SYDNEY CENTRAL CITY PLANNING PANEL

COUNCIL ASSESSMENT REPORT

Panel Reference	2018CCI006
DA Number	DA/961/2015/B
LGA	City of Parramatta Council
Proposed Development	Section 4.55(2) modification to DA/961/2015 for the approval of a mixed use development comprising 619 residential apartments and 12 commercial tenancies within a building with a 4 storey podium and 3 tower forms, two level basement with 633 car parking spaces. The proposed modification includes the internal reconfiguration of retail tenancies resulting in 24 retail tenacies (12 additional) and an increase to retail gross floor area of 497.7sqm (overall increase of gross floor area from 55,868m ² to 56,365.7m ²), reduction in the size of the residential foyers to the western building (Tower C), changes to the basement layout comprising the deletion of western driveway ramps, an additional 39 parking spaces (overall increase from 633 to 672 parking spaces) and the relocation of the retained vehicular access ramps, loading and plant facilities, waste room and general service areas. The application is to be determined by the Sydney Central City Planning Panel.

ASSESSMENT REPORT – MODIFICATION OF CONSENTS

Figure 4 – Proposed Basement level 2 plan under DA/961/2015/B. Source: Team2 Architects, Revision H-b, dated 14 December 2018

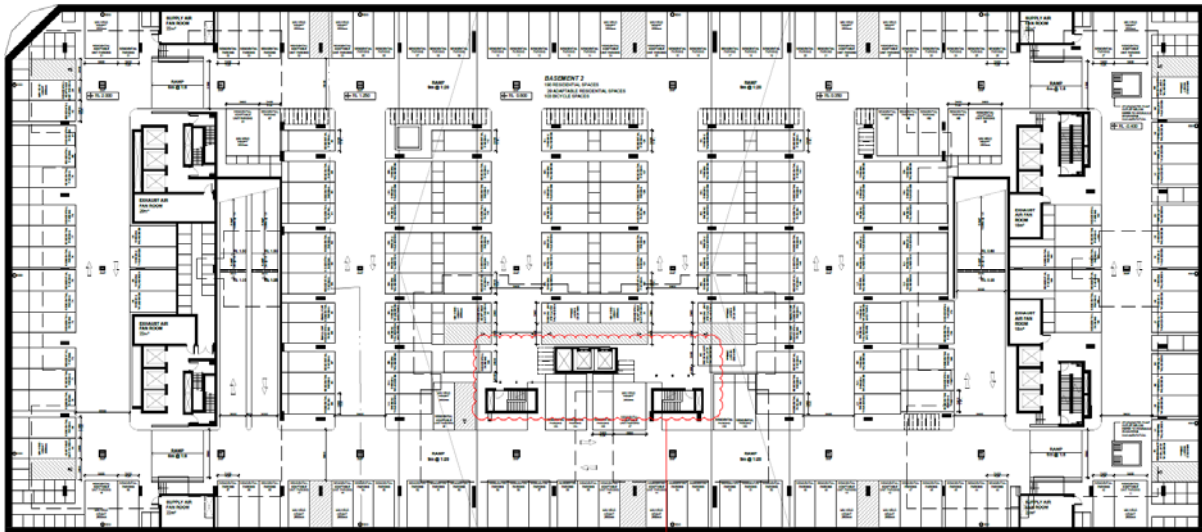
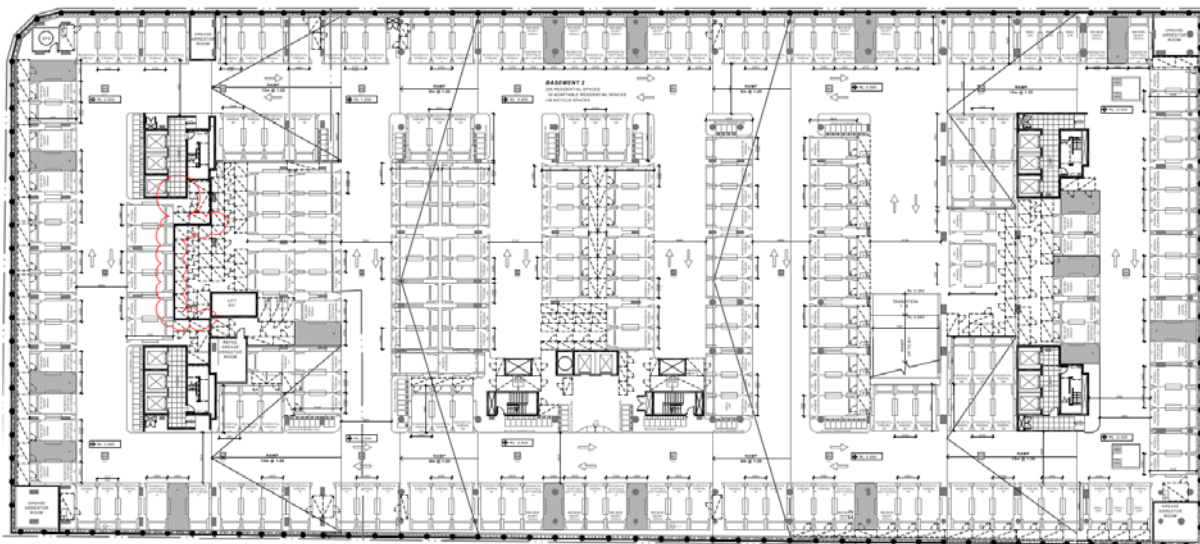
- Deletion of the western ramp accessing other above ground parking levels and reconfigurations to the car parking allocation;
- Increase the number of residential car parking spaces by 10, from 190 to 200;
- Increase the number of adaptable residential spaces by 1, from 29 to 30;
- Increase the number of bicycle spaces by 10, from 103 to 148; and
- Reconfigurations to consist of 200 residential car parking spaces, 30 adaptable residential spaces, 148 bicycle spaces, five (5) grease arrestor rooms, fire stairs, storage cages and 9 lift cores.

Figure 6 – Proposed basement level 1 plan under DA/961/2015/B. Source: Team2 Architects, Revision H-b, dated 14 December 2018

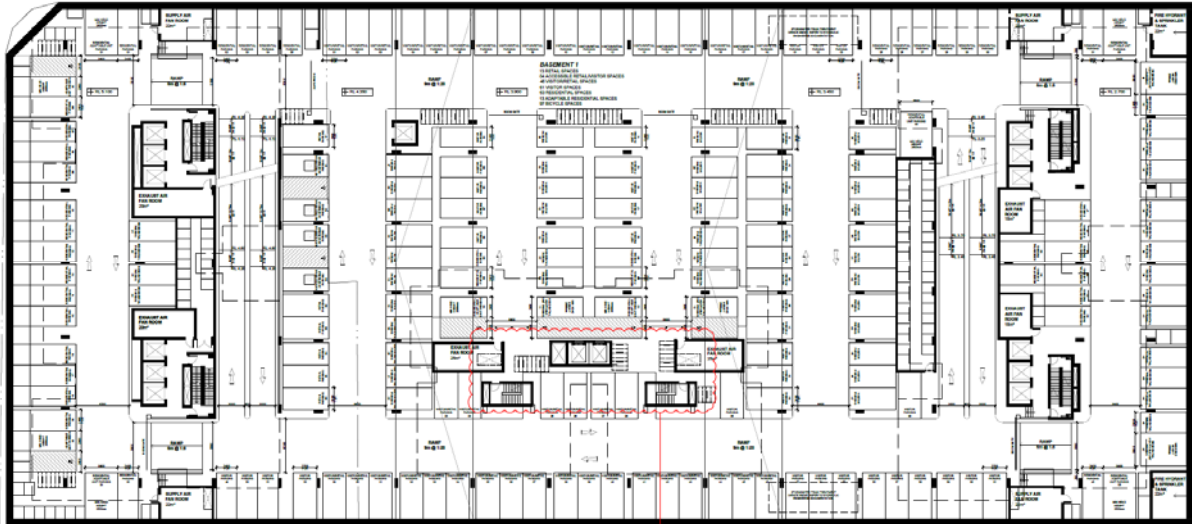
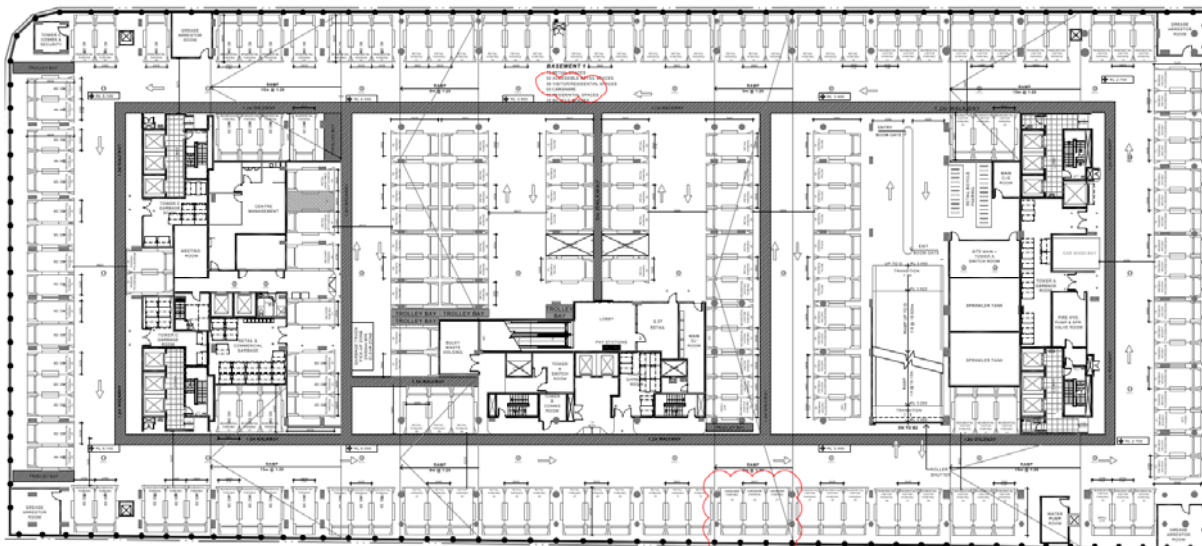
- Deletion of the western ramp accessing other above and below ground parking levels and reconfigurations to the car parking allocation;
- Increase the total number of parking spaces by 28, from 200 to 228;

- Reduce the number of accessible retail parking spaces by 2, from 4 to 2;
- Reduce the number of residential/visitor parking spaces by 46, from 107 to 61 (which includes 3 carshare spaces);

- Increase the number of retail parking spaces by 59, from 13 to 72;
- Reduce the number of residential car parking spaces by 13, from 63 to 50;
- Delete the 13 adaptable residential parking spaces;

- Reduce the number of bicycle spaces by 72, from 97 to 25;
- Addition of dedicated pedestrian access ways between car parking spaces to lift lobbies;
- Addition of dedicated trolley bays for the retail tenancy #21; and

- Reconfigurations to consist of 50 residential car parking spaces, 30 adaptable residential spaces, 148 bicycle spaces, five (5) grease arrestor rooms, fire stairs, storage cages, shopping trolley bays, 9 lift cores, centre management and meeting rooms, communication/security rooms, water pump room, sprinkler rooms, switch room, bulky waste holding room, residential and commercial garbage rooms, fire hydrant pup and sprinkler valve room and cleaning room.

Figure 8 – Proposed ground floor plan under DA/961/2015/B Source: Team2 Architects, Issue I-b, dated 14 December 2018

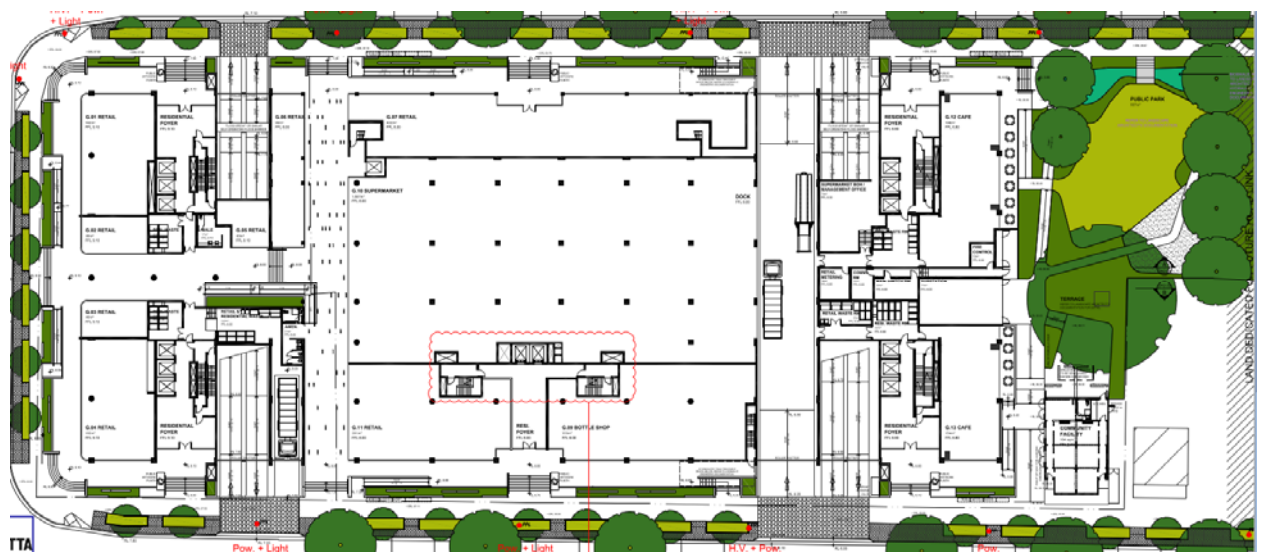
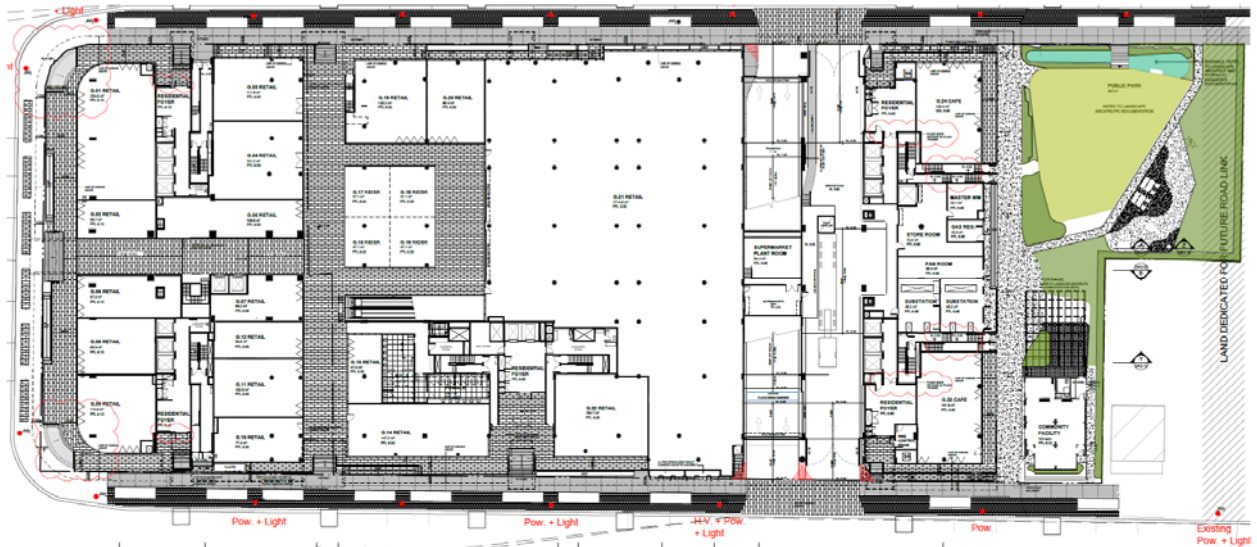
- Community facility building (RL 6.32) with kitchen and amenities;
- Public park approximately 907m² with associated paving and landscaping and dedication for future site through link;

- Retail tenancy #1 (RL 9.10) approximately 204m² with access from Cowper Street/Rowell Street;
- Retail tenancy #2 (RL 9.10) approximately 58m² with access from Rowell Street;

- Retail tenancy #21 (RL 8.00) approximately 1,714m² with access from through site-link including adjoining supermarket plant room (RL 6.95) and supermarket backroom (RL 8.00) with access from plant room/loading dock;

- Fire control room (RL 6.80) adjacent to southern residential foyer to eastern building (Tower A) with access from East Street;
- Two (2) substation rooms, fan room, store room and master/gas regulator rooms (RL 6.95) with access from service road/through site-link; and
